APPROVED AS NOTED:

PROJECT: GA. RHEUMATOLOGYCLINIC	CITY OF TYRONE	SCALE: 1" = 20'
SHEET: TREE PROTECTION & LANDSCAPE PLAN	7TH DISTRICT	DRAWN BY: GPH
LL 136		DATE: 06-18-21

L1

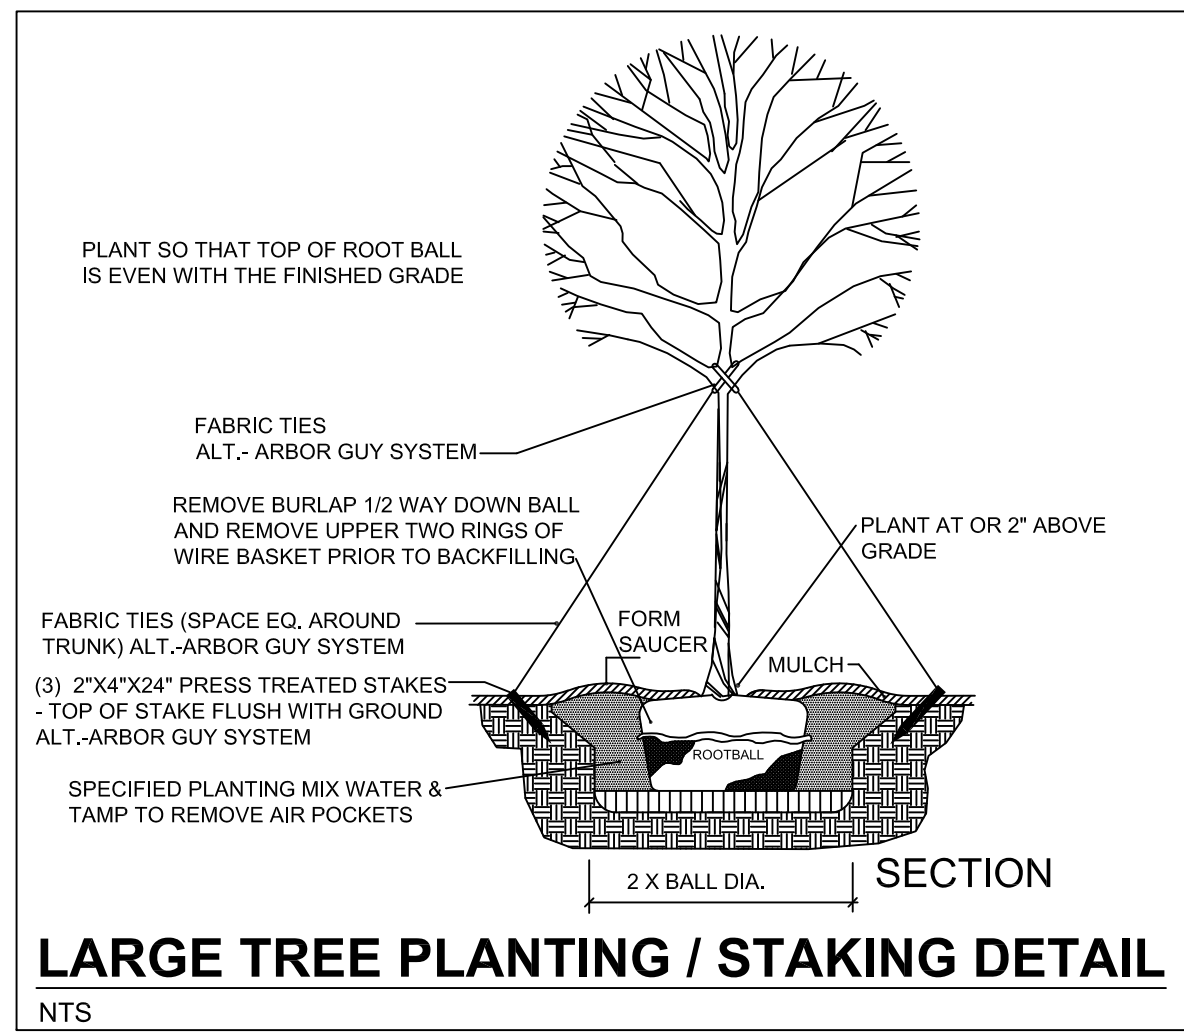
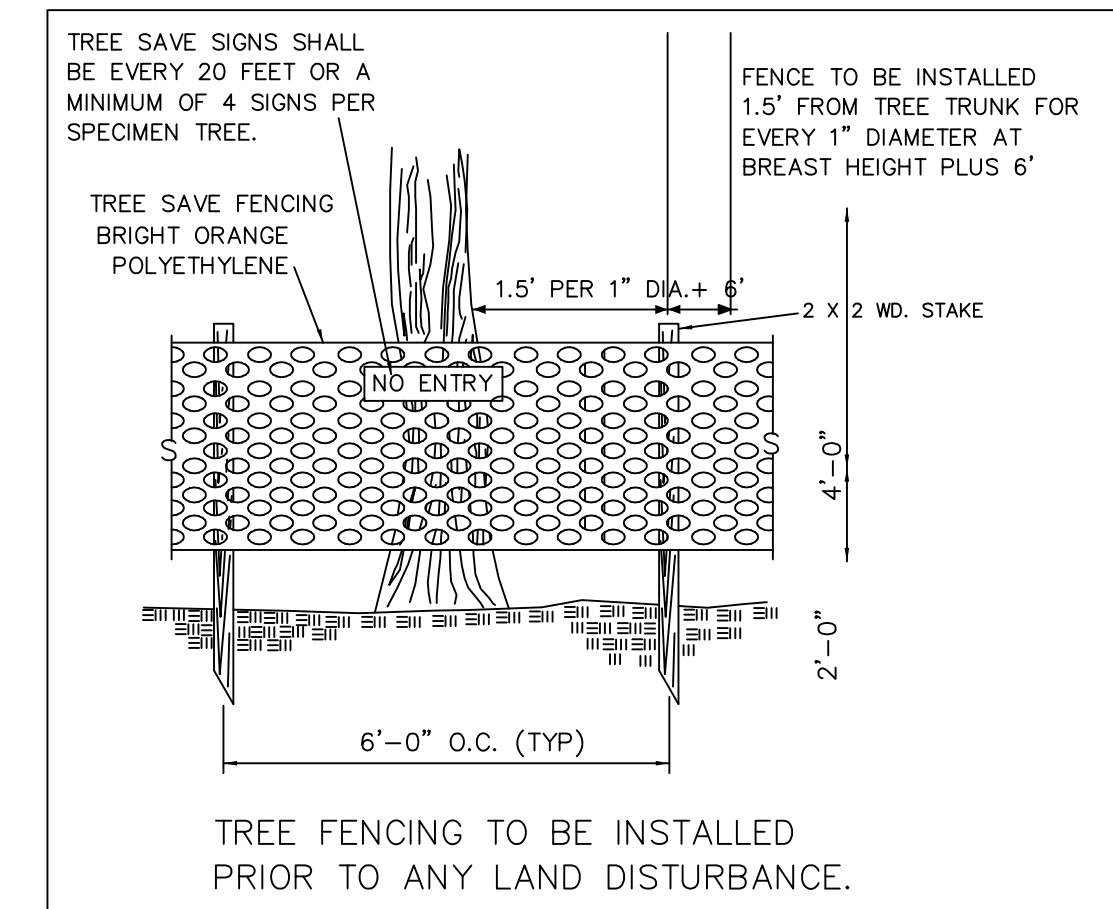
12/15/2021
Staff Approval as Noted -
Revision to "Landscape Notes" item 3 -
"Sod installation is required in the areas
specified in the plan.
Unless otherwise specified in the plan
and/or deemed necessary by the site's
design professional, areas will be
sodded per the property owner's
discretion.

- MULCH ALL BEDS WITH PINESTRAW MULCH TO A DEPTH OF 4".
- GRASS ALL DISTURBED AREAS WITH GRASSING PER EROSION CONTROL SPECIFICATIONS.
- ~~SOD AREAS PER OWNERS DISCRETION.~~ SEE TO 12/15/2021 "APPROVED AS NOTED" REVISED LANGUAGE FOR NOTE 3.
- NO TREES TO BE SAVED ON THIS SITE.
- ESTIMATED COST OF LANDSCAPE INSTALLATION: \$20,000
- AT STREET INTERSECTIONS KEEP PLANTINGS BELOW TWENTY FOUR (24) INCHES AND TREE LIMBS ABOVE SIXTY (60) INCHES.
- TOWN STAFF, UPON SITE INSPECTION AND CONCEPTUAL LANDSCAPE PLAN REVIEW, MAY REQUIRE AN APPLICANT TO NATURALIZE AREAS WHICH VISUALLY IMPAIR PUBLIC RIGHTS-OF WAYS.
